F/22/93835

MOORLANDS FARM, BOTLEY ROAD, WEST END, SOUTHAMPTON, SO30 3HD

Consultation Response Summary

Response to Comments

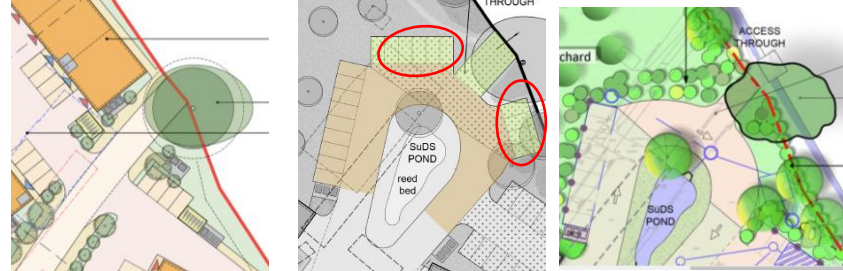
e) Tree Retention Confirm viable  EBC Tree Officer: agrees it should be possible to retain the tree.	The layout has again been amended. T8, is an Aspen. It is a robust species, which is well able to survive the proposals, as originally set out and as now amended, taking into account its existing RPA and the new site plan.
